Parts Change Information

SUBJECT → GR/FR Compensator Modification

APPLIES TO: **GR, FR** PARTS COMPATIBILITY: **Not Compatible** **DOCUMENT NO: 20393**

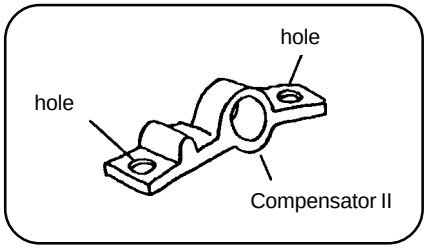
Summary: The screw holes of the Compensator have been enlarged in order to improve the movement of the Clamp Plate during master disposal operation. New part numbers have been registered. Parts availability begins 120 days from issue of bulletin.

New Part Number	New Part Name
019-12241-005	Compensator II
019-12242-001	Collar; Compensator
635-19624-003	Stepped Screw; ϕ6x2.3;4x8

A3 Drum

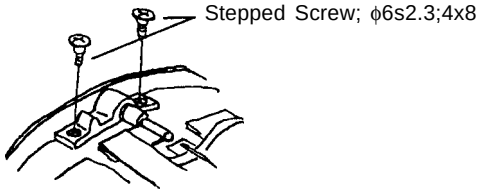
Procedure: If problems are encountered with jamming of the Clamp Plate, upgrade the drum with modified parts.

Note: There is a difference between upgrading the A3 drum and other drums.
